City of Mississauga Department Comments

Date Finalized: 2021-12-22	File(s): A541.21 Ward 1
To: Committee of Adjustment	
From: Committee of Adjustment Coordinator	Meeting date:2022-01-13 1:00:00 PM

Property Address: 1447 Blenheim Road

Appendix 1 – Transportation and Works Comments

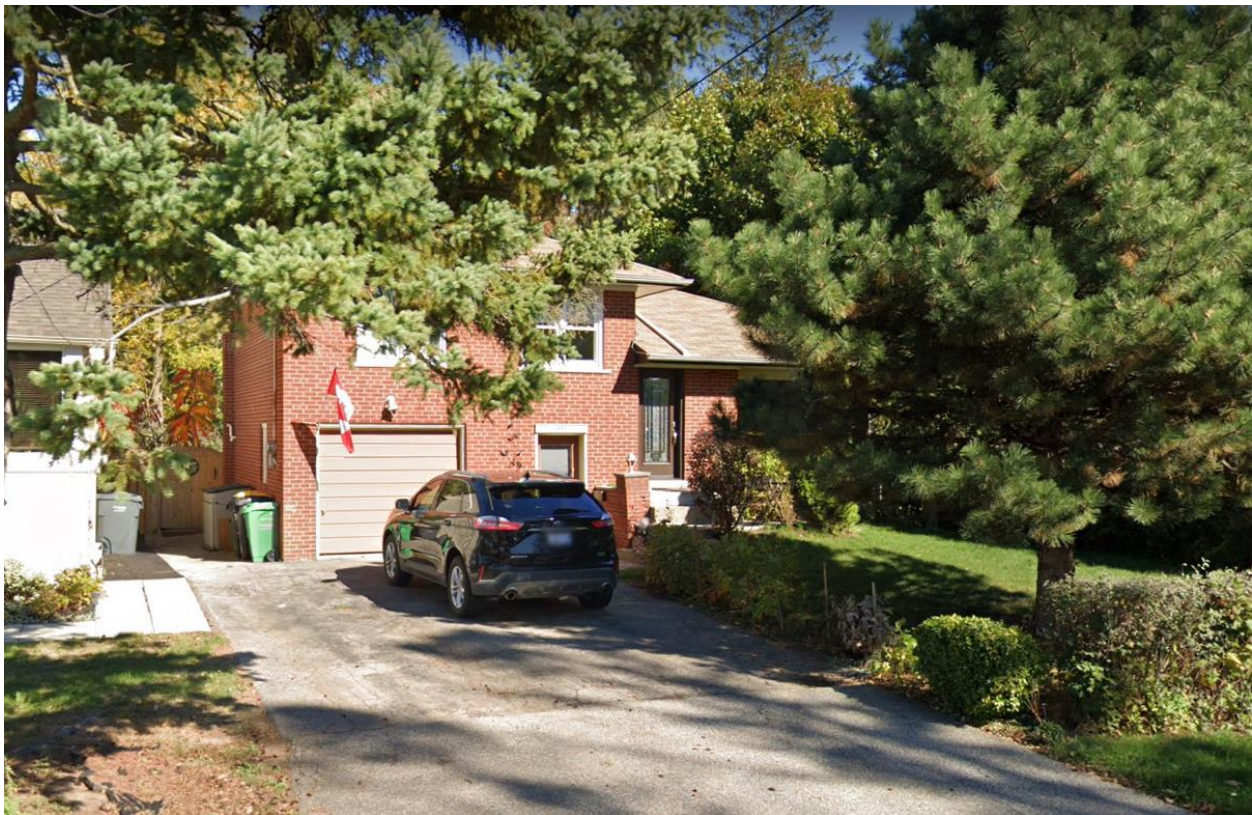
We are noting for Committee's information that any Transportation and Works Department concerns/requirements for the proposed addition will be addressed through the future Site Plan/Building Permit Application process.
